SNUPPS

Standardized Nuclear Unit
Power Plant System

September 1, 1981

SLNRC 81-82 FILE: 0541
SUBJ: ICSB Review

FIGURE 7.6-4

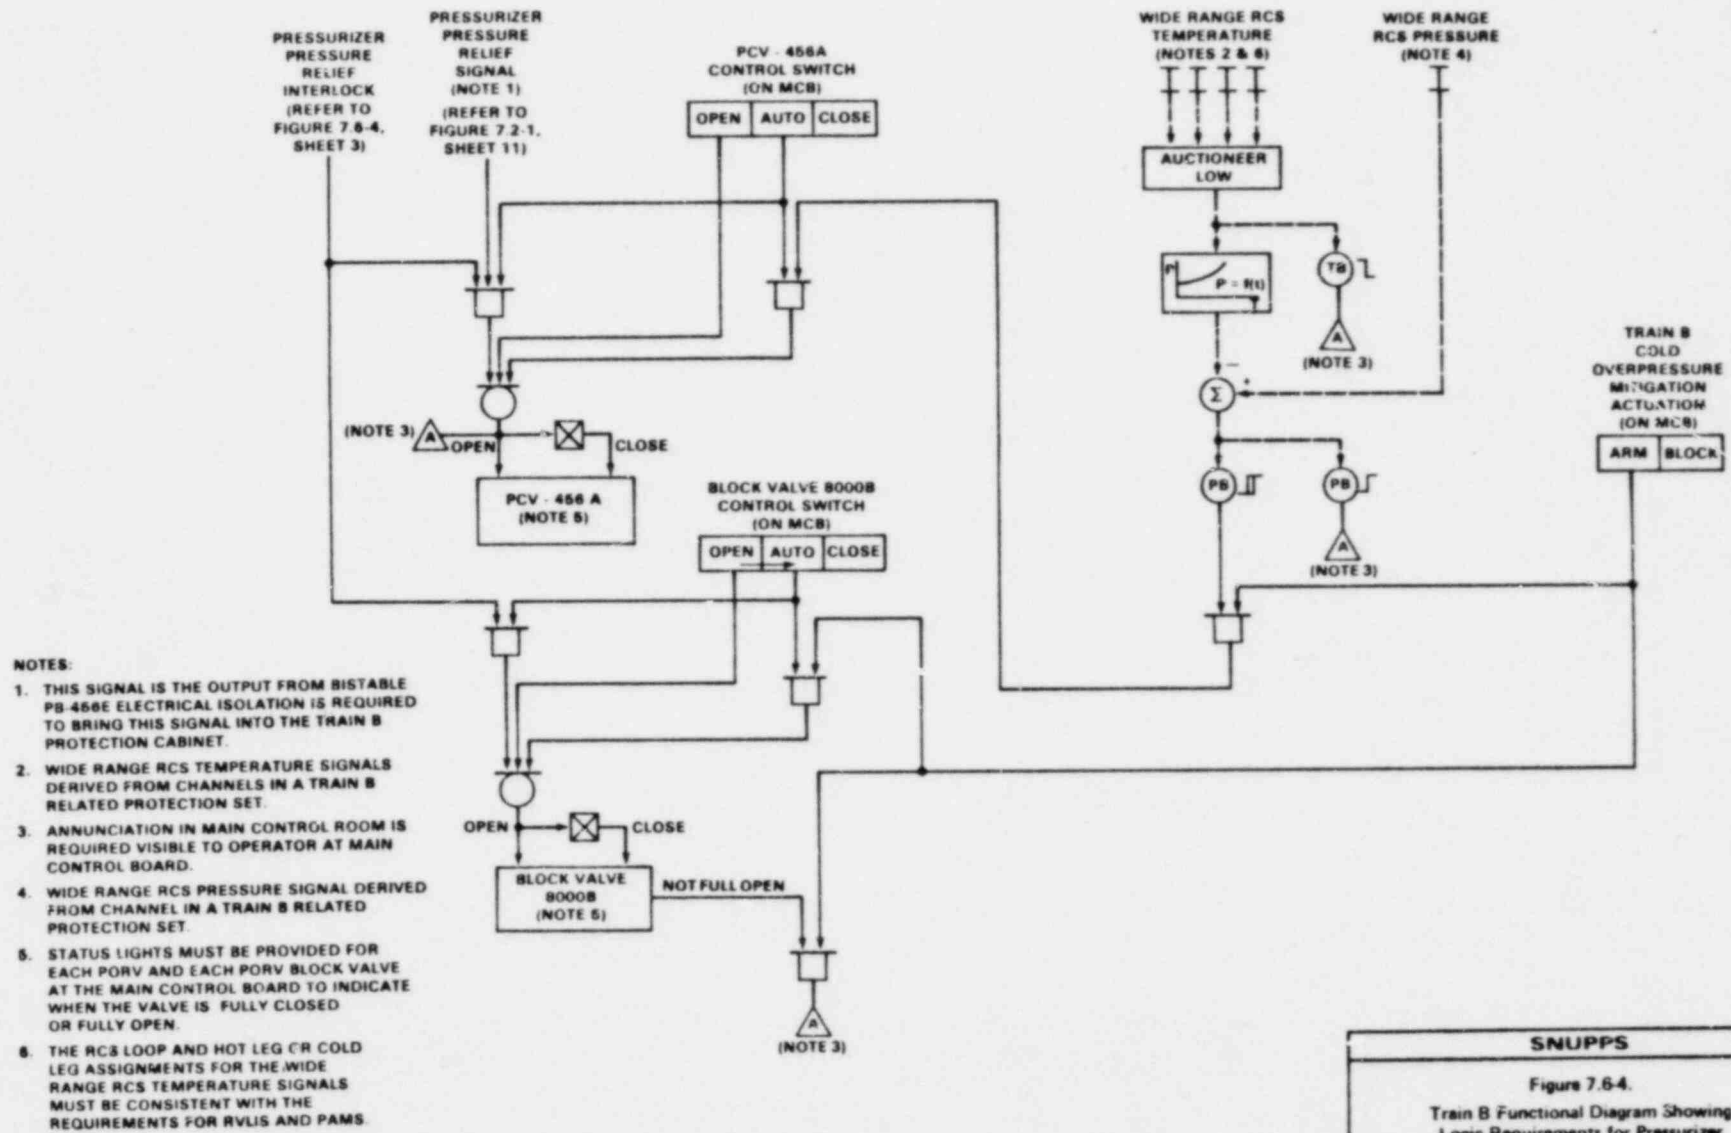
7. Agenda item #39 concerned low temperature overpressure protection. Included in the Enclosure B FSAR changes are revised descriptions of the SNUPPS design. The NRC questioned the failure modes in this system. The pressurizer PORV block valves are normally open and are designed to close upon loss of opening signal. The pressurizer PORVs are normally closed and are designed to utilize energize-to-open logic. The PORVs are designed to close upon loss of energy or loss of opening signal. Therefore, loss of opening signal will result in both PORV and PORV block valve closure, and accidental RCS depressurization is precluded. Since each PORV and its associated block valve are on a separate power supply from the other PORV and its block valve, the pressurizer pressure relief system is designed such that no single failure can prevent opening of at least one flow path to the pressurizer relief tank and except for postulated second random failures, all flow paths to the pressurizer relief tank can be closed.

~~As shown on this figure~~ ^(pressure and temperature) the generating station variables required for this interlock are channelized as follows:

- Replace with Insert (X)
- a. Protection Set I
 - (1) Wide range RCS temperature from hot legs
 - (2) Wide range RCS pressure (PT 405)
 - b. Protection Set II
 - (1) Wide range RCS temperature from cold leg
 - c. Protection Set IV
 - (1) Wide range RCS pressure (PT 403)

*Replace
with the
following sheets.*

Figure 7.6-4.
Train B Functional Diagram Showing
Logic Requirements for Pressurizer
Pressure Relief System
Sheet 1

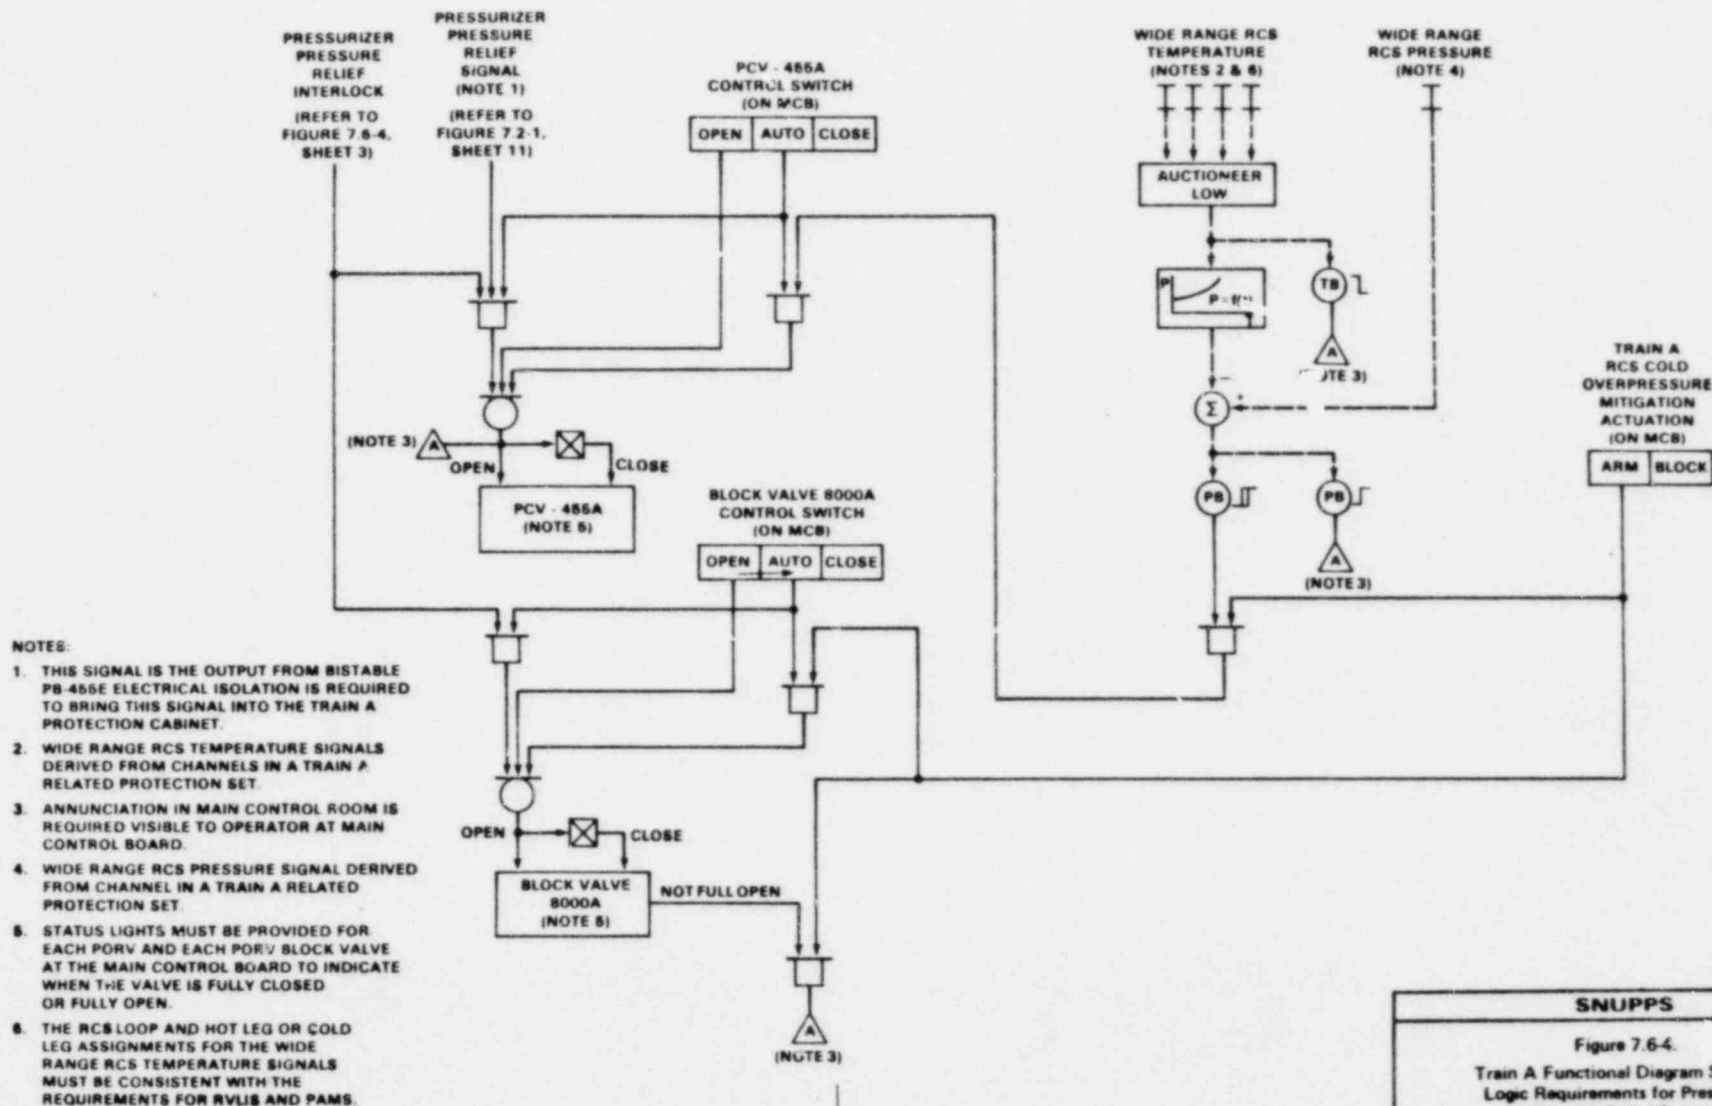
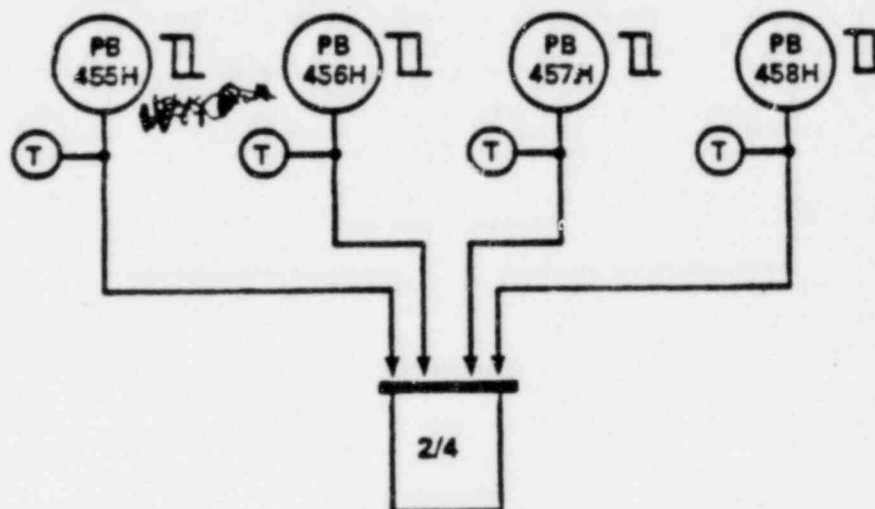
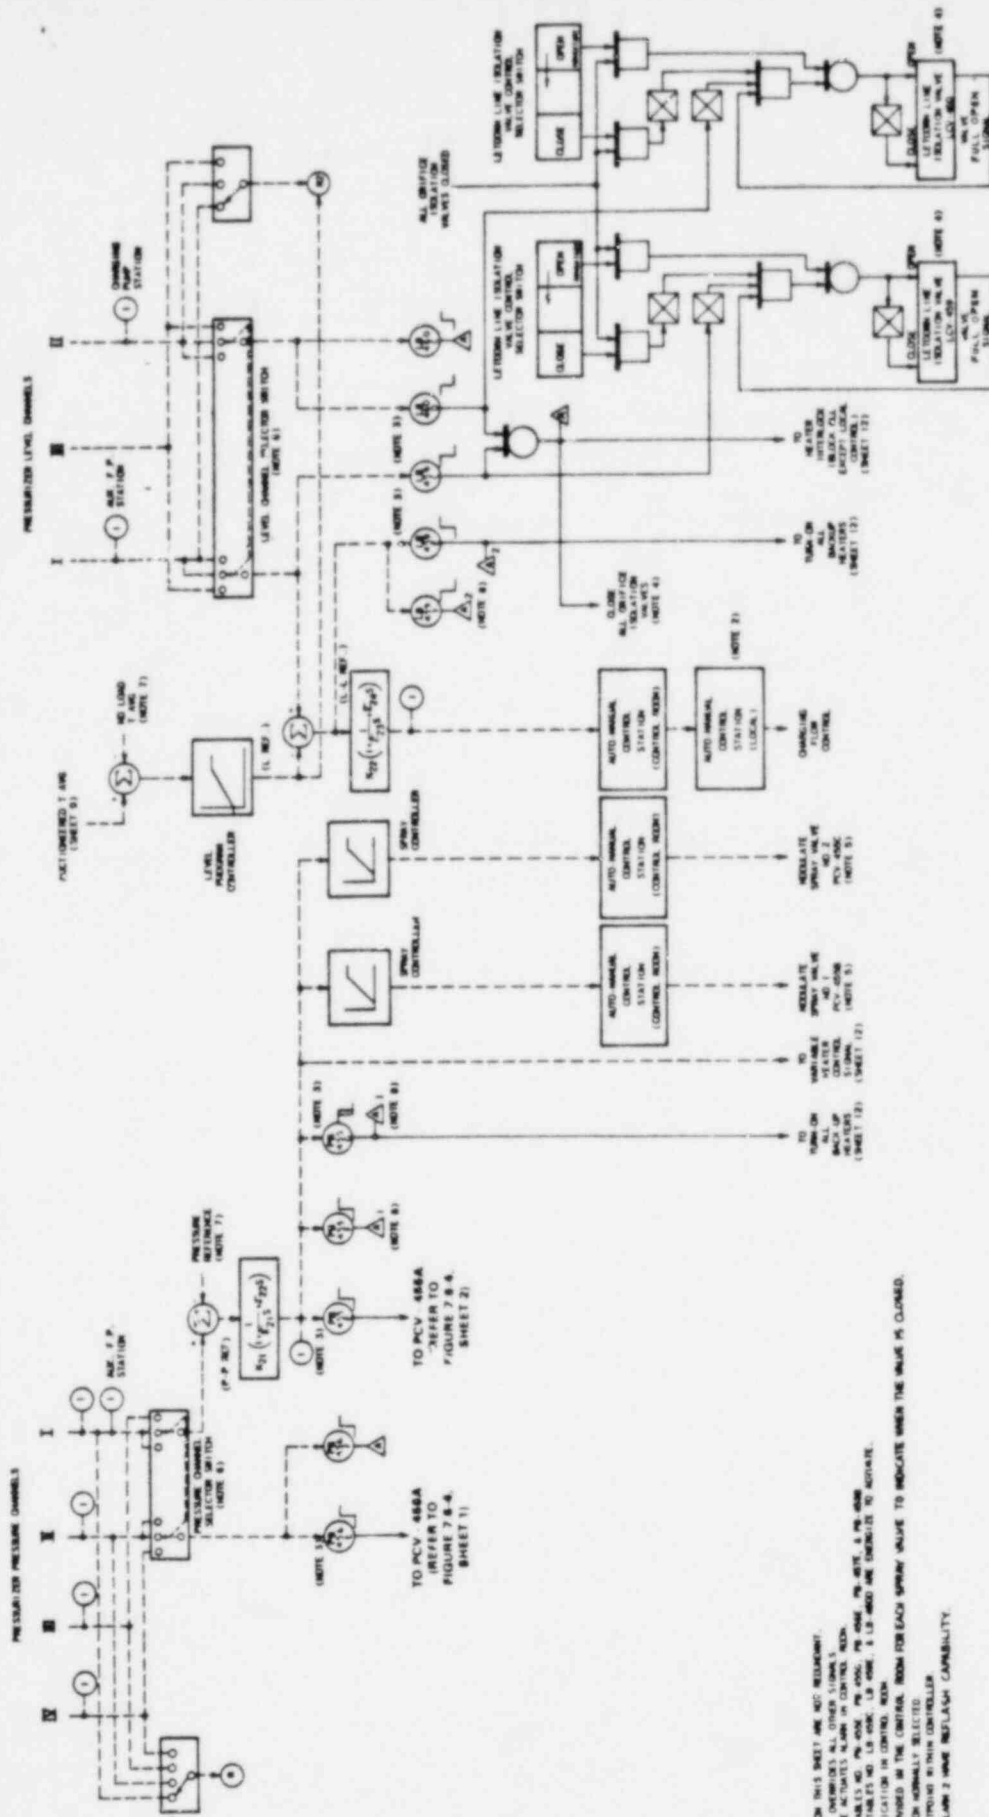
The interlock functions that provide pressurizer pressure control are derived from process parameters as shown on Figure 7.2-1, sheet 11 and the interlock logic functions as well as process parameter inputs required for low temperature operation as shown on Figure 7.6-4. The functions shown on Figure 7.6-4 include those needed for the PORV block valves as well as the pressurizer PORVs to meet both interlock logic and manual operation requirements where manual operation is

PORV Opening Band – Turbine Trip
With Condenser Unavailable
Figure 1.

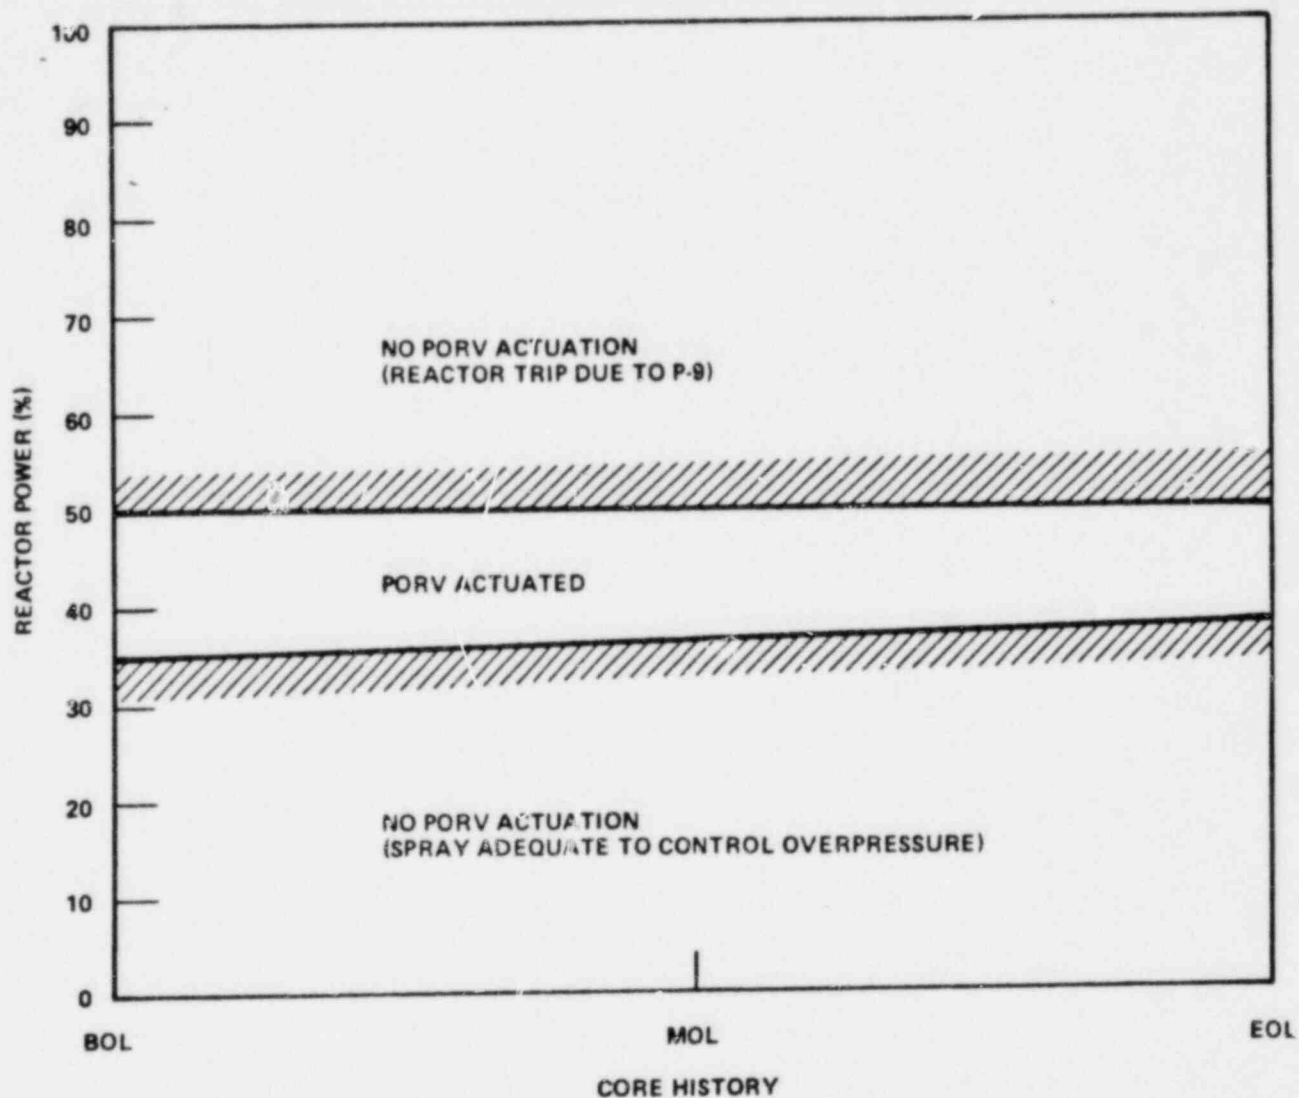
The NRC has raised the question of whether the pressurizer power operated relief valves would be actuated for a turbine trip without reactor trip below a power level of 50% (P-9 setpoint). An analysis has been performed using realistic yet conservative values for the core physics parameters (primarily reactivity feedback coefficients and control rod worths), and a conservatively high initial power, average reactor temperature (T_{AVG}), and pressurizer pressure level to account for instrument inaccuracies.

An additional analysis has been performed to determine the consequences (specifically the likelihood of the pressurizer power-operated relief valves opening) of having a turbine trip due to a loss of condenser vacuum.

The major difference between this ~~new~~ analysis and the one presented ^{above} ~~is~~ is that now the normal steam dump system is unavailable, and the steam relief must be done through the atmospheric relief valves. Since there is a longer delay time before the atmospheric reliefs reach their setpoint (in comparison to the normal steam dump system) and their capacity is about one-half of the steam dump system, there is an increased likelihood that the pressurizer PORVs will open.

Figure 1 shows the plant operating ranges for which the pressurizer PORVs will open for a turbine trip due to a loss of condenser signal. Above 50% power, a turbine trip will cause a reactor trip (due to P-9 setpoint), and the pressurizer PORV setpoint will not be reached. Below a power level of 35%-40% (depending on fuel burnup), the pressurizer spray rate is adequate to maintain the pressurizer pressure below the setpoint. Therefore, only in the narrow band between about 35% and 50% power will the pressurizer PORVs open for a loss of condenser.

Based upon the operating history of current plants, the chances of getting a condenser unavailable signal (and hence a turbine trip) is about 156 out of 10⁷ operating hours. ~~Assuming~~ Assuming 98% plant availability and a 40-year plant lifetime, this works out to about 4 condenser unavailable turbine trips occurring during the normal life of a plant. Assuming an equal chance of having the plant operate anywhere between 0% and 100% power (an unrealistic value, since they usually operate either at a full or no load level), the chances of having a condenser unavailable signal generate a transient which would result in the opening of the pressurizer PORVs is less than one per plant lifetime.

Figure 1

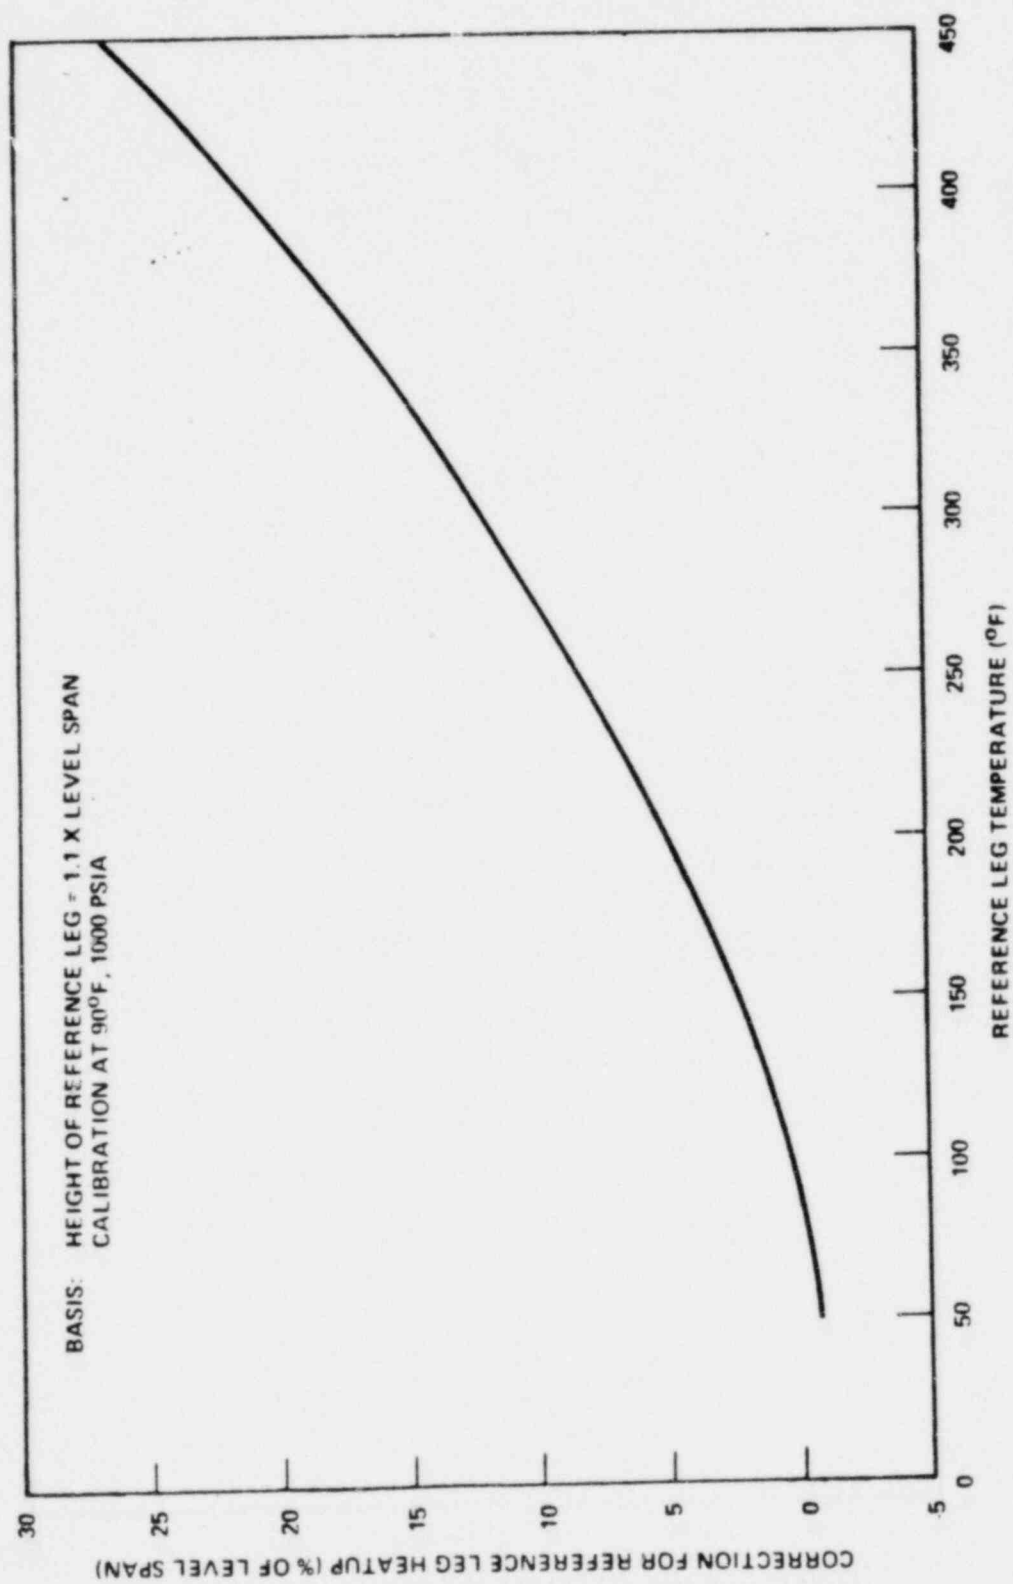
8. Agenda item #51 concerned steam generator water level reference leg heatup and the resulting errors in indicated level. Enclosure C is a report describing this matter for the SNUPPS design.

Figure 1 shows the level bias as a function of reference leg temperature, assuming $H_L/H = 1.1$ and the calibration conditions of: containment temperature = 90°F, steam generator pressure = 1000 psia. These are conservative values applicable to the SNUPPS plants.

The reference leg heatup error for 292°F containment temperature is 11% of narrow level span from Figure 1.

The low-low setpoint will be raised 11% of narrow range span to compensate for the effects of reference leg heatup. The bases for this change are analyses specific to the SNUPPS plants.
